NEPAL ELECTRICITY AUTHORITY
Project Management Directorate
Project Management Department
Marsyangdi-Kathmandu 220 kV Transmission Line Project

ICB-PMD-MKTLP-076/077-02: Design, Supply, Installation and Commissioning of 220 kV Air insulated Substation (AIS) in Matatirtha, Kathmandu and 220kV Gas Insulated Substation (GIS) in Markichowk, Marsyangdi

CLARIFICATION NO:-04 RESPONSE TO BID QUERIES

ICB-PMD-MKTLP-076/077-02

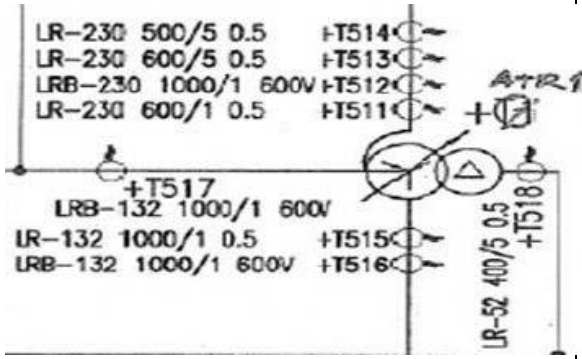
195.		Line Diagrams : A) 220KV AIS & 132KV Substation	<p>a) On page 40 of the 426-page document, the 220kV main bus of section I and II are shown as overhead 4-split flexible wire, but wire type and specification are unmarked. (Is it AAC pure aluminum or ACSR steel core aluminum stranded wire? What is the cross-sectional area of the single core wire?) Please see single-line diagram 1 in Attachment.</p> <p>b) On page 40 of the 426-page document, the 220kV bypass main bus are shown as overhead 2-split flexible wire, but wire type and specification are unmarked. (Is it AAC pure aluminum or ACSR steel core aluminum stranded wire? What is the cross-sectional area of the single core wire?) Please see single-line diagram 1 in Attachment.</p> <p>c) On page 40 of the 426-page document, is the female overhead flexible wire 4-split or 2-split? Can we be informed the wire type and specification? (Is it AAC pure aluminum or ACSR steel core aluminum stranded wire?)</p>	<p>a) 220kV Main Bus-1&2 are envisaged with Quad Moose ACSR. Details of ACSR Moose shall be as per requirement of technical specification.</p> <p>b) 220kV Transfer Bus is envisaged with Twin Moose ACSR. Details of ACSR Moose shall be as per requirement of technical specification.</p> <p>c) 220kV Jack Bus for Bus coupler bay is envisaged with Quad Moose ACSR and that of other bay is Twin Moose ACSR. Details of ACSR Moose shall be as per requirement of technical specification.</p> <p>d) 220kV Marsyangdi D/c Line is envisaged with Twin Moose ACSR. Details of transmission Line conductor shall be provided to the</p>

S. No.	Reference Section & Clause	Description in Bid Document	Bidder's Queries/Comments	NEA's Clarification
			<p>What is the cross-sectional area of the single core wire?) Please see single-line diagram 1 in Attachment.</p> <p>d) On page 40 of the 426-page document, Line 1 and Line 2 of the 220kV MARSYANGDI Line are shown as overhead 2-split flexible wire, but wire type and specification are unmarked. (Is it AAC pure aluminum or ACSR steel core aluminum stranded wire? What is the cross-sectional area of the single core wire?) Please see single-line diagram 1 in Attachment.</p> <p>e) On page 40 of the 426-page document, the 220kV transformer HV side is indicated with $\text{C} 100$ tubular buses+2(MOOSE), but wire type and specification are unmarked.) Please see single-line diagram 1 in Attachment.</p> <p>f) On page 43 of the 426-page document, is the cross-road section at the circuit breaker of the connection of tubular buses? Are the wires between other equipments flexible wires? The wire type and specification are unmarked. (Is it AAC pure aluminum or ACSR steel core aluminum stranded wire? What is the cross-sectional area of the</p>	<p>successful bidder in the event of award.</p> <p>e) 220kV Transformer HV side overhead conductor and tube bus are envisaged with Twin Moose ACSR and 4" IPS Aluminium tube respectively. Details of ACSR Moose & 4" IPS Aluminium tube shall be as per requirement of technical specification.</p> <p>f) Substation Layout & SLD are enclosed with the bidding documents. Further detailed shall be provided to the successful bidder in the event of award.</p> <p>g) Please follow the clarification provided on S. No. 18. Bidder shall quote meeting requirement of technical specification and BPS.</p> <p>h) This is rail cum Contrete road for shifting and installation of transformers. Bidder shall quote meeting requirement of technical specification and BPS.</p>

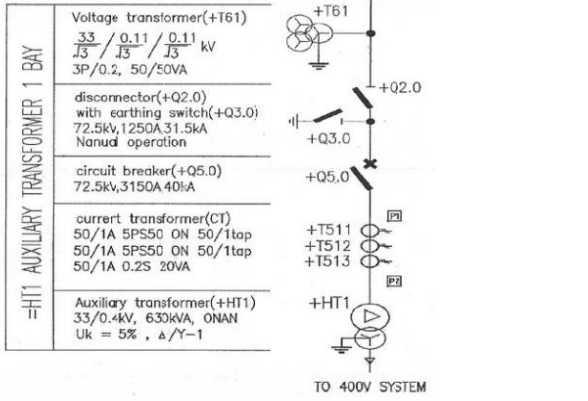
200.	Vol-III, I-B Extension of Marsyangdi Substation (220 kV GIS & 132 kV AIS)	Current Differential Relay for other end of line 4 Nos	<p>a) what's this mean? Main-I Protection is distance Protection, Main-II Protection is Line current differential protection. I think it already contains in item b.</p> <p>b) Do 220kV buscoupler need protections ? These are not included in VOL III Bidding Equipment list.</p>	<p>a) Please refer our clarification S.No. 54.</p> <p>b) Please refer our clarification S.No. 55.</p>
